**Class 2 Permit Modification Request**

**Addition of a Shielded Container**

**Waste Isolation Pilot Plant  
Carlsbad, New Mexico**

**WIPP Permit Number - NM4890139088-TSDF**

Figure 1  
Shielded Container

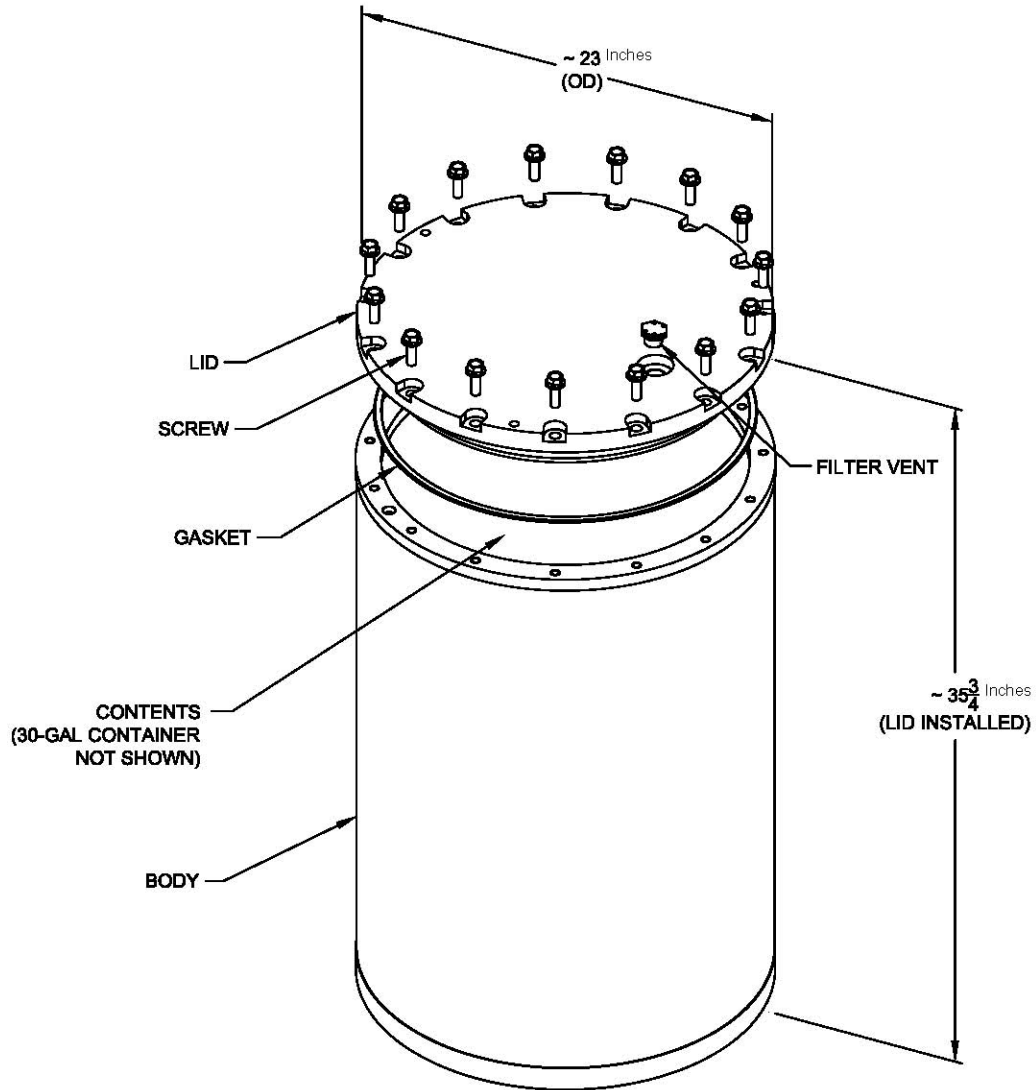
34 The Permittees are proposing to add a new payload container to the Permit which is designated  
35 as a shielded container (shown in Figure 1). This container is similar in size to a standard  
36 55-gallon drum. The shielded container body side wall is constructed of an approximately 3/16-  
37 in. inner steel shell, an approximately 1-in. middle layer of lead, and an approximately 1/8-in.  
38 outer steel shell. The shielded container lid and base are each constructed of approximately 3-  
39 in. steel plate. The lid is bolted on. A gasket of silicone rubber is utilized for lid closure. The  
40 empty weight of the shielded container is approximately 1,726 pounds. The shielded container  
41 accommodates a 30-gallon steel drum which will contain RH TRU mixed waste. Both the  
42 shielded container and its 30-gallon steel drum are vented in accordance with transportation  
43 requirements. The shielded container vent port includes a lead shield plug. Although the 30-

44 gallon drum will be packaged with RH TRU mixed waste, the lead construction of the shielded

1 container will reduce the surface dose rate at the outer surface to less than 200 millirem per  
2 hour (mrem/h), allowing the container to be handled as CH TRU mixed waste.

Figure 2  
3-Pack Assembly of Shielded Containers with Axial and Radial Dunnage

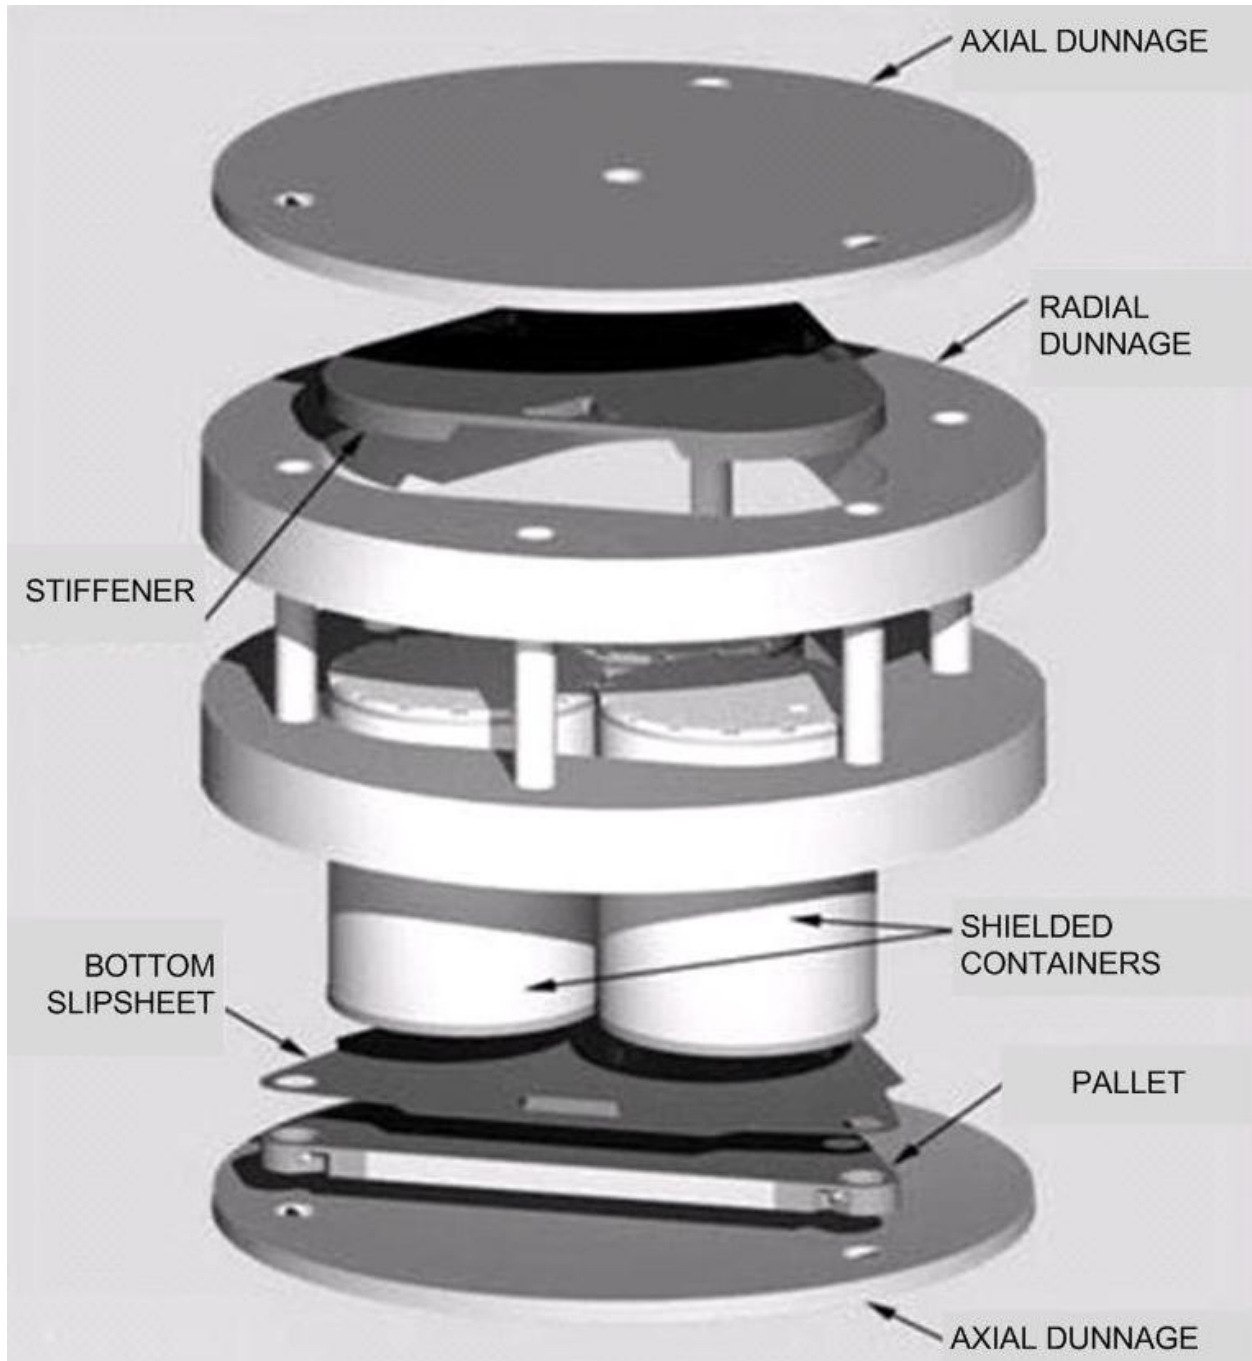
28  
29 The shielded containers will be assembled for shipment from the generator site in a 3-pack  
30 configuration on a triangular pallet surrounded by radial and axial dunnage components. These  
31 components are designed to keep the load from shifting during transportation. They will be  
32 transported as a single 3-pack configuration within the HalfPACT packaging. Currently, RH  
33 TRU mixed waste is transported in RH 72-B packaging. The shielded containers will be  
34 transported in HalfPACTs with no more than three HalfPACTs per shipment. Not all RH TRU  
35 mixed waste will be packaged in shielded containers. Therefore, both RH 72-B and HalfPACTs  
36 will be shipped to the WIPP facility. However, using shielded containers has the potential to  
37 reduce the number of shipments, therefore, there is no additional risk. Furthermore, regardless  
38 of the number of shipments, the Permittees are not requesting an increase in the storage

1 fixtures and equipment in the CH Bay portion of the Waste Handling Building. Once accessible  
2 after the HalfPACT lids have been removed, the top axial dunnage will be removed prior to  
3 removing the 3-pack assembly from the HalfPACT (see Figure 2). Next, the 3-pack assembly,  
4 the radial dunnage, the bottom slipsheet and the triangular pallet will be lifted from the  
5 HalfPACT using the installed guide tubes and placed on a facility pallet. When in storage in the  
6 Waste Handling Building, RH TRU mixed waste in shielded containers is subject to the more  
7 stringent visual inspection requirements for CH TRU mixed waste. The facility pallet will then be  
8 moved to the repository in the same manner as other CH TRU mixed waste. The 3-pack  
9 assembly will be placed singly on the floor using the slipsheet. The triangular pallet will be  
10 removed and not emplaced. The 3-pack will be placed in the interstitial spaces among the CH

Figure 3  
Shielded Containers – Randomly Placed in the Interstitial Spaces in Waste Rows

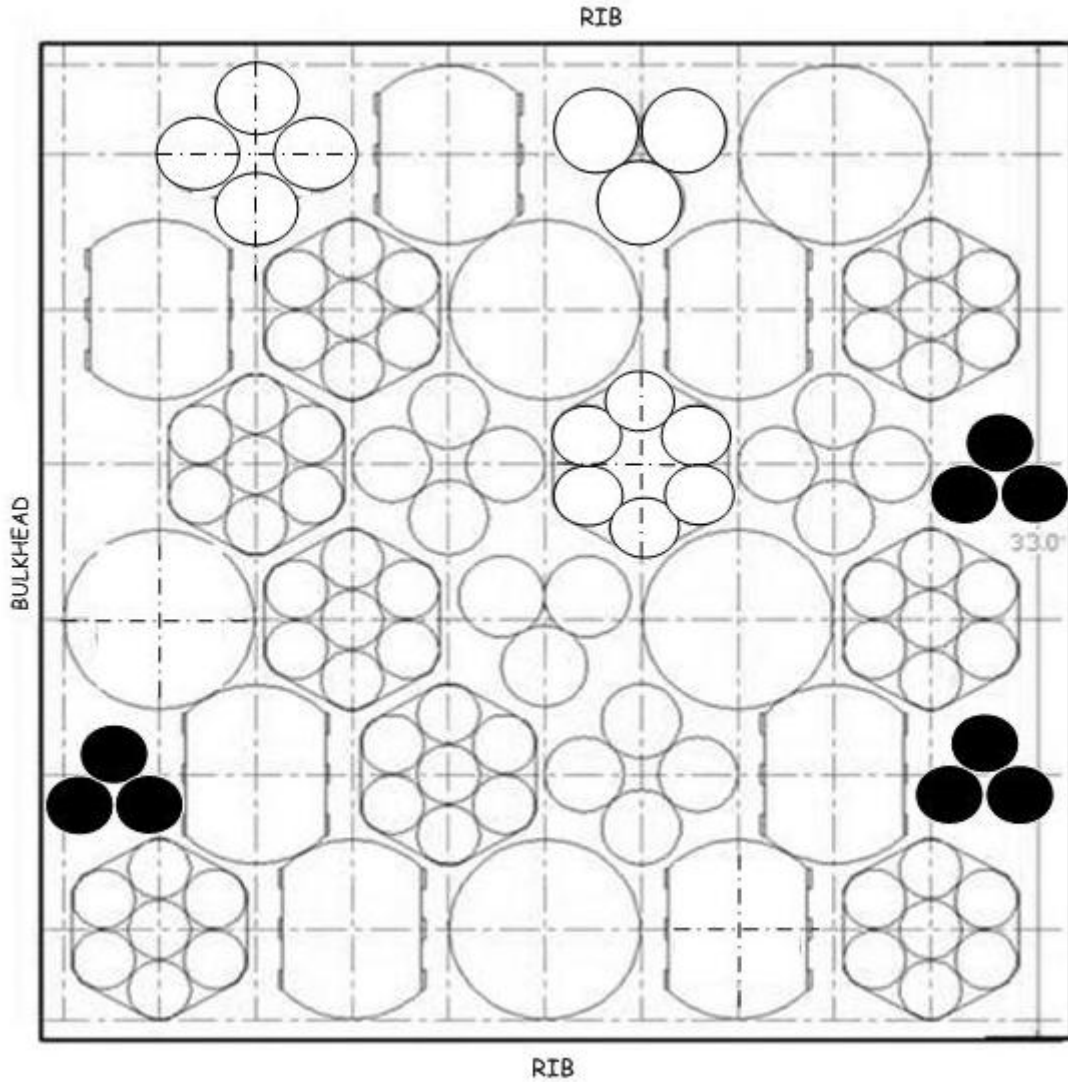
11 TRU mixed waste (see Figure 3). In order to meet the stacking stability requirements of Permit  
12 Attachment A2, Section A2-2b, shielded containers will not be stacked more than two high, and  
13 no other waste assemblies or backfill MgO sack will be placed on top of a 3-pack assembly of  
14 shielded containers<sup>2</sup>. Emplacement of the 3-pack assembly of shielded containers will be  
15 performed using existing waste handling equipment and fixtures.

Figure A1-37  
Typical Shielded Container

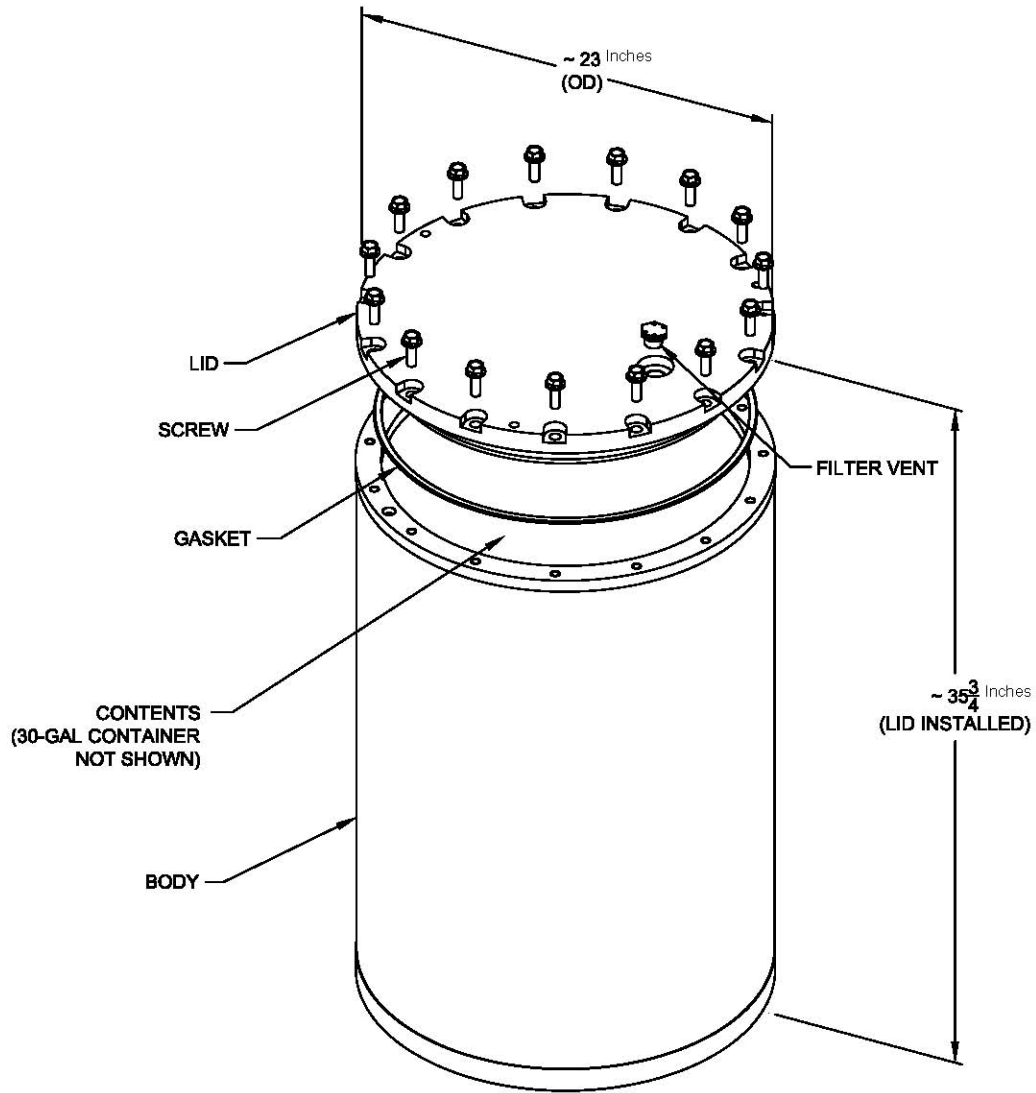
- 29  
30 3. Add a figure of the shielded container (Permit Attachment A1, Figure A1-  
31 37).
- 32  
33 4. Add "Shielded Containers" to Permit Attachment C1, Sections C1-1a and  
34 C1-1a (1) and revise Permit Attachment C1, Table C1-8 indicating that  
35 the 55-gallon drum DAC bounds the shielded container.

Permit Attachment A1, Table A1-2	Revise Table A1-2 to add shielded containers.	B-8
Permit Attachment A1, Figure A1-37	Add "Figure A1-37 Typical Shielded Container"	B-9
Permit Attachment A2, Section A2-2a(1)	Add "two 3-packs of shielded containers" Delete "or"	B-10
Permit Attachment A2, Section A2-2b	Add "and shielded containers" Delete "(e.g., TRUPACT IIs or HalfPACTs)," Add "one 3-pack of shielded containers" Add "or shielded containers"	B-10
Permit Attachment A2, Table A2-1	Revise Table A2-1 to add shielded containers.	B-11

7  
8 Remote-Handled TRU mixed waste received at the WIPP facility in shielded containers will be  
9 arranged as 3-packs. A summary description of the shielded container is provided below. The  
10 shielded container meets the requirements for DOT specification 7A (Figure A1-37).

11  
12 Shielded containers consist of a 30-gallon inner container with a gross internal volume of 4.0 ft<sup>3</sup>  
13 (0.11 m<sup>3</sup>). One or more filter vents will be installed in the shielded container lid to prevent the  
14 escape of radioactive particulates and to prevent internal pressurization. The shielded container  
15 is constructed with approximately one inch of lead shielding on the sides and approximately  
16 three inches of steel on the top and bottom of the container and will be used to emplace RH  
17 TRU mixed waste. The shielding will allow it to be managed and stored as CH TRU mixed  
18 waste.
